Southern Nuclear Operating Company  
Vogtle Electric Generating Plant Units 3 and 4 Combined License Application  
Response to Request for Additional Information Letter No. 013

Enclosure: Response to NRC RAI Letter No. 013 on the VEGP Units 3 & 4 COL Application  
Involving Geotechnical Information

**Response to NRC RAI Letter No. 013  
on the VEGP Units 3 & 4 COL Application  
Involving Geotechnical Information**

Figure 1 – Active Lateral Earth Pressure Diagrams for NI Below Grade Walls

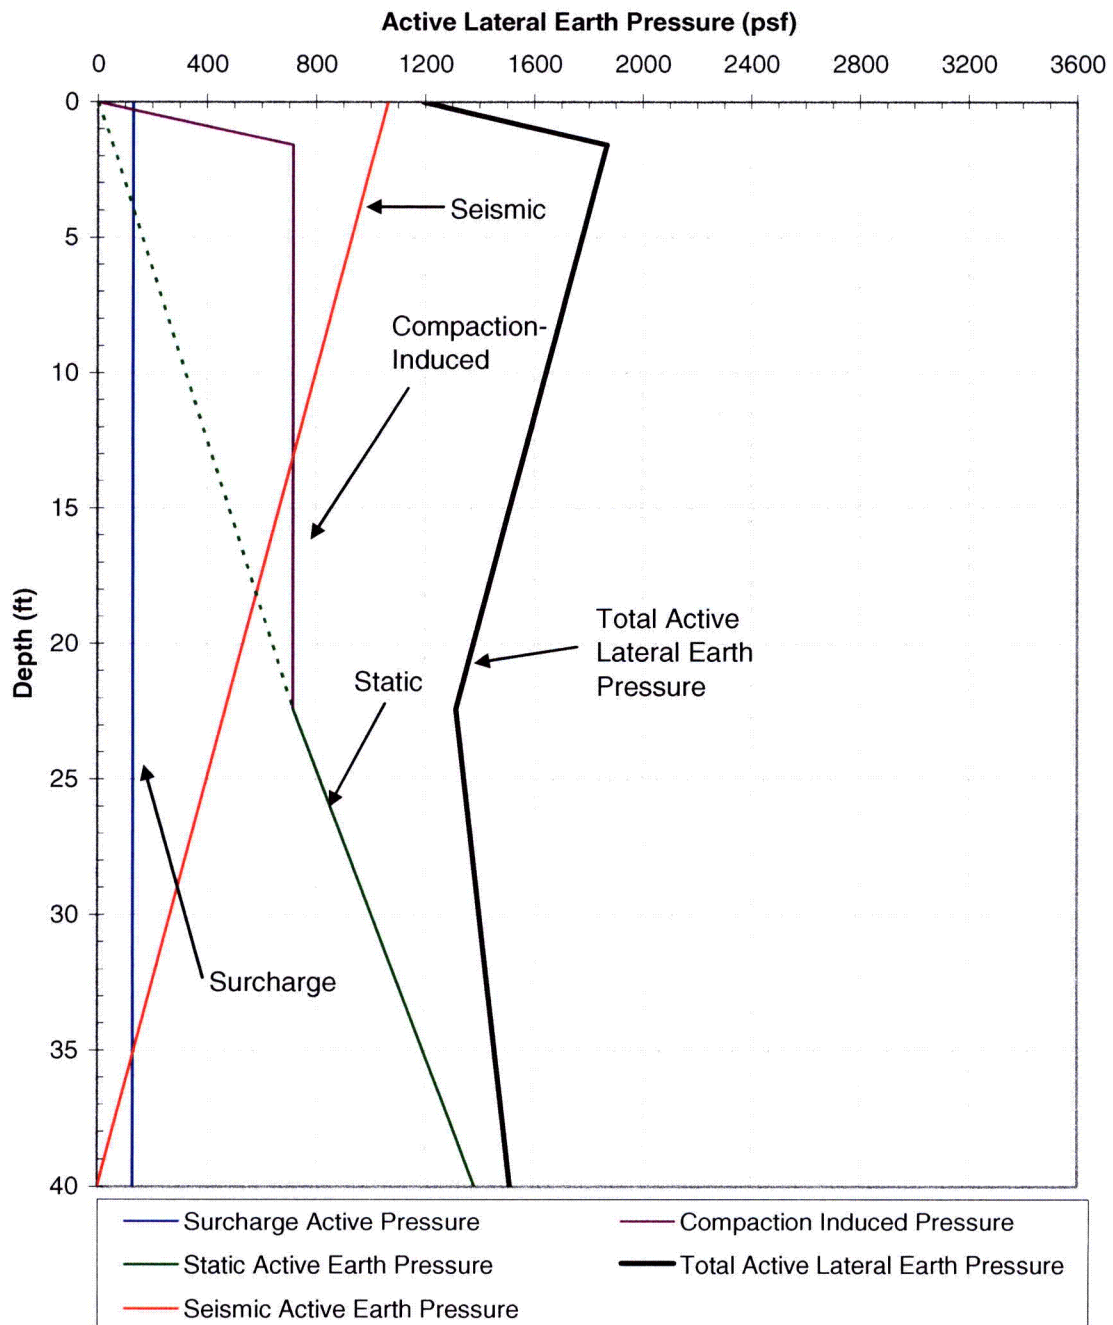
COL Action Item 2.5-11 requires an applicant referencing the AP1000 DCD to describe the methodology used to determine the static and dynamic lateral earth pressures and the hydrostatic pressures acting on the safety-related structures. The applicant referred to ESP SSAR Section 2.5.4 for the information to resolve this action item. However, in the SSAR, the applicant did not address in sufficient detail either the lateral earth pressure or the hydrostatic pressures at the site. Please provide an explanation of the methodologies used to determine the pressures as required by the DCD.

Sample earth pressure diagrams for the maximum height of the NI wall (about 40 ft) are developed in Figure 1 for active conditions and in Figure 2 for at-rest conditions. These diagrams were developed assuming level ground surface, a post-construction groundwater level below the basemat elevation (no hydrostatic pressure), an areal surcharge pressure of 500 psf, and compaction-induced pressure increases. A saturated unit weight of 133 pcf was used to calculate the static and seismic lateral earth pressures.
